3.5 Missile Protection

The information in this section of the reference ABWR DCD, including all subsections, tables, and figures, is incorporated by reference with following departure and supplements.

STP DEP 3.5-1 (Table 3.5-1 and Figure 3.5-2)

Figure 3.5-2 Low-Trajectory Turbine Missile Ejection Zone

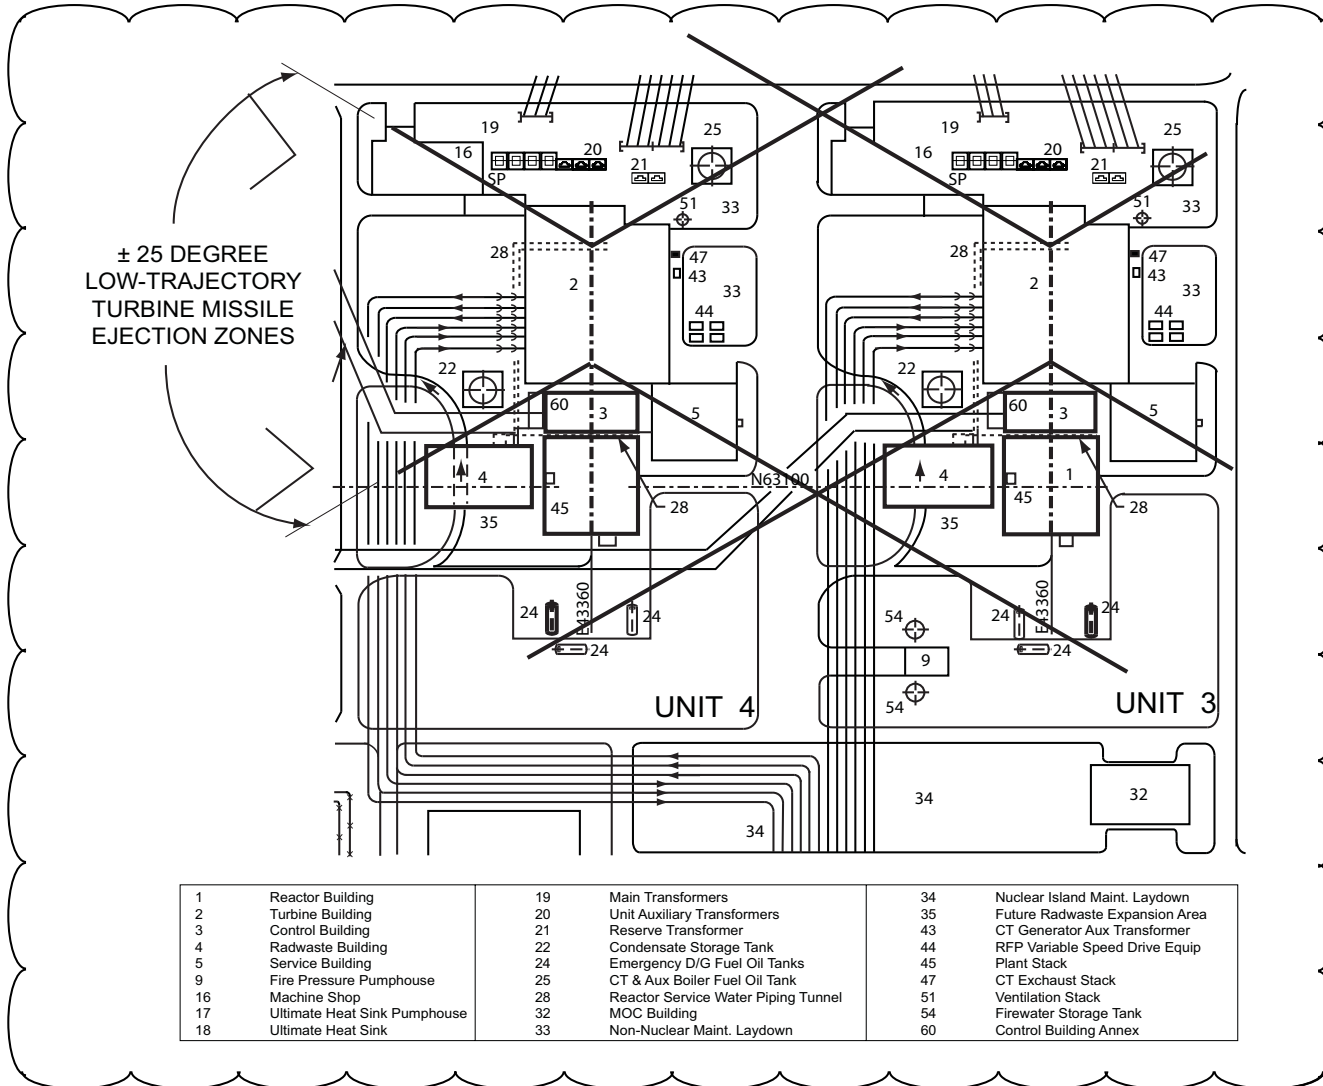
STP DEP 3.5-1

~~Acceptance Criteria 1 of SRP Section 3.5.1.3 considers a plant with a favorable turbine generator placement and orientation and adhering to the guidelines of Regulatory Guide 1.115 adequately protected against turbine missile hazards. Further, this criterion specifies that exclusions of safety-related structures, systems or components from low trajectory turbine missile strike zones constitutes adequate protection against low trajectory turbine missiles. The turbine generator placement and orientation of the ABWR Standard Plant meets the guidelines of Regulatory Guide 1.115 as illustrated in Figure 3.5-2.~~

The STP 3 & 4 turbine generator placement and orientation in relation to essential systems of the adjoining unit are illustrated on Figure 3.5-2. Per Regulatory Guide 1.115, the STP 3 & 4 turbine generator placement and orientation is considered unfavorable. Per Acceptance Criteria 1 of Standard Review Plan Section 3.5.1.3 for unfavorable turbine generators, a value of 10^{-2} per year per plant was chosen as a conservative value for the product of strike probability (P_2) and damage probability (P_3). The criteria for unfavorable turbine generator orientation given in Standard Review Plan Table 3.5.1.3-1 and provided in Table 3.5-1 was assumed for the missile generation probability (P_1). The resulting probability of unacceptable damage from a main steam turbine missile (P_4), which is $P_1 \times P_2 \times P_3$, is less than 10^{-7} per year per plant.

Therefore STP 3 & 4 main steam turbine generator placement and orientation meets the acceptance criteria of Standard Review Plan 3.5.1.3 and the guidelines of Regulatory Guide 1.115.
